**CASE NO. 2020-00040**  
**TURKEY CREEK SOLAR, LLC**  
**RESPONSES TO SITING BOARD'S FIRST REQUEST FOR INFORMATION**

**RE: Turkey Creek Solar Impact Study, Garrard County, KY**

EXHIBIT E: Simulation from 2 neighboring properties

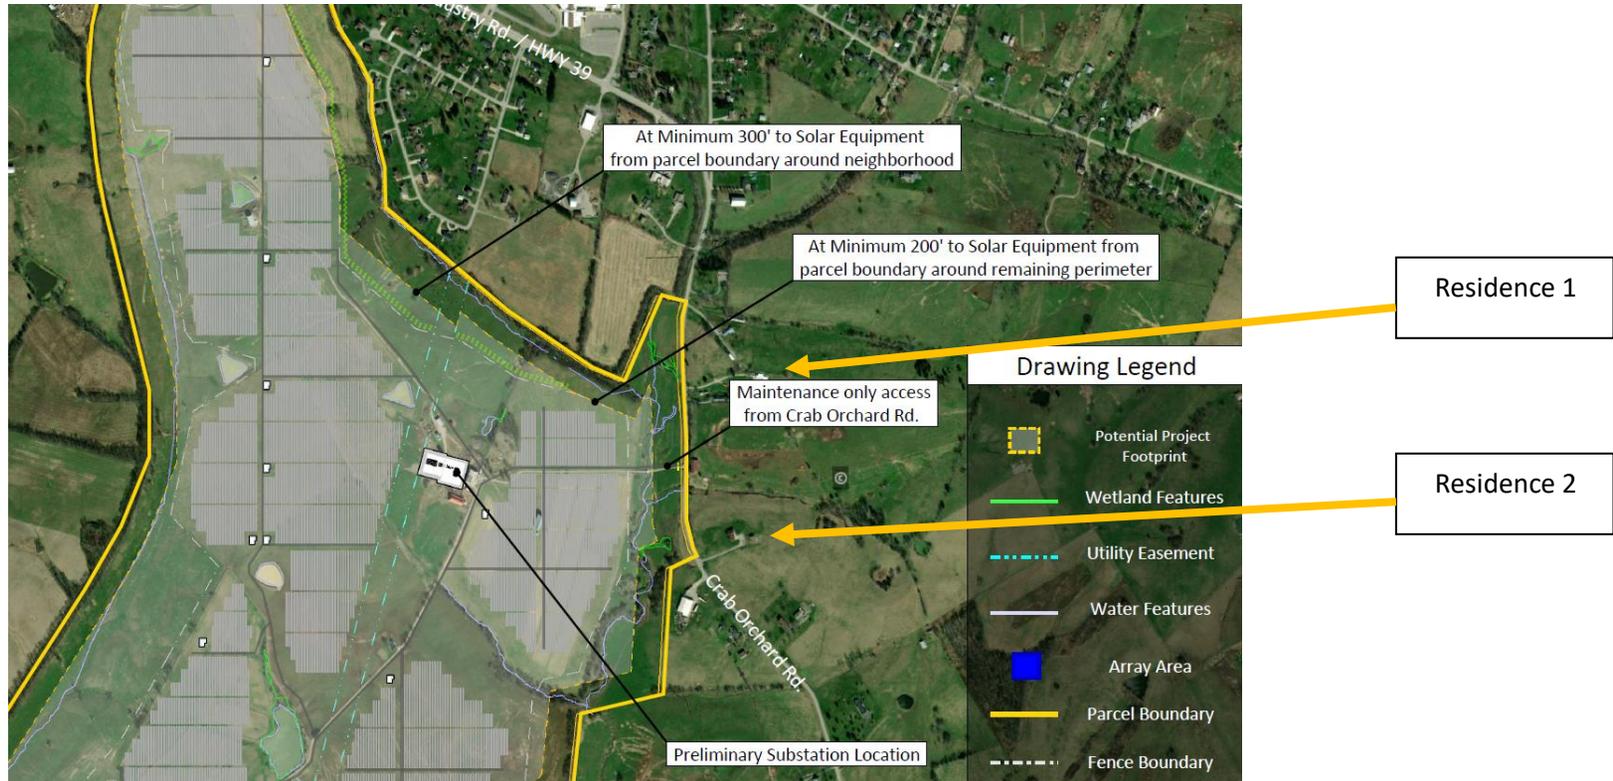
b. Identify any concerns that were received by Turkey Creek resulting from the public outreach efforts and state how Turkey Creek addressed those concerns.

b. Carolina Solar Energy heard concerns from two adjoining neighbors at our Neighborhood Dinner relating to their viewshed, and our communications with them are described below. We also received a call from a person who described a memory about an old historical map of a Native American site on the property. After significant investigation including interviews with local residents with knowledge of the history of the area, and hiring an archaeological consultant, we were not able to locate any evidence of this. These three comments were the only concerns that Carolina Solar Energy has received regarding the project.

These two properties were chosen because of the topography of the area. Both properties sit up on a hillside, looking onto the Curry Farms property.
